PCN-20220228 TE0720-03 to TE0720-04 Hardware Revision Change

Company	Trenz Electronic GmbH
PCN Number	PCN-20220228
Title	TE0720-03 to TE0720-04 Hardware Revision Change
Subject	Hardware Revision Change
Issue Date	2022-03-11

#19 Changed schematic documentation.

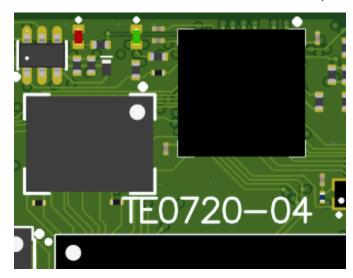
Type: DOC Change

Reason: Documentation optimization.

Impact: None. B2B information, legal notices, change history, system overview, power diagram and power page are inserted or changed. Schematic page number changes.
